### Health Impact Assessment Recommendation Document for

McKinley Paper Company Stock Preparation Project Port Angeles, Washington

June 2019

Figure 4: Location of key receptors evaluated in the HIA relative to McKinley's project-related maximum 1-hr formaldehyde concentration

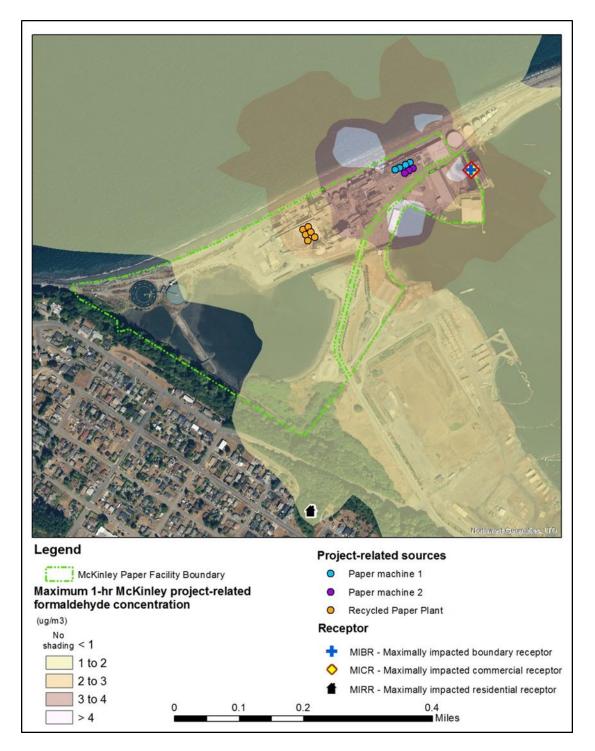
To determine if the impacts of McKinley's emissions are acceptable, Ecology requires that sources estimate exposures and health risks for those that are most likely to receive the highest exposures. Ramboll identified maximally impacted boundary, commercial, and residential receptors (MIBR, MICR, and MIRR, respectively) for evaluating acute and chronic exposure to formaldehyde emitted from their facility (Figures 2, 3, and 4).
